Environmental Management Consulting, Inc.

Facility Safety Audit
Platteville School District
October 10, 2005

On September 27, 2005, Todd J. Swenson of Environmental Management Consulting, Inc. (EMC) performed a safety audit of the Platteville School District's Elementary Schools.

Gray Early Learning Center
Boiler Room

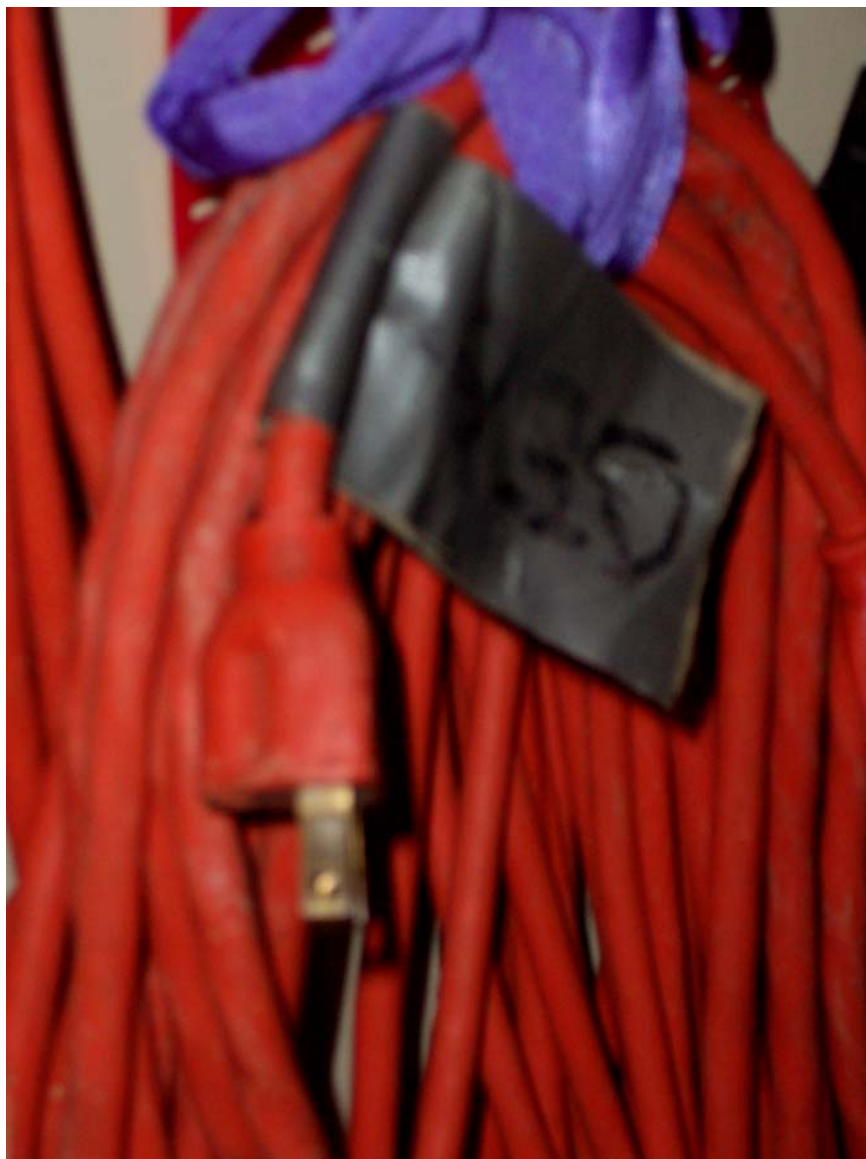
Photo 4 - Ground prong missing on extension cord.
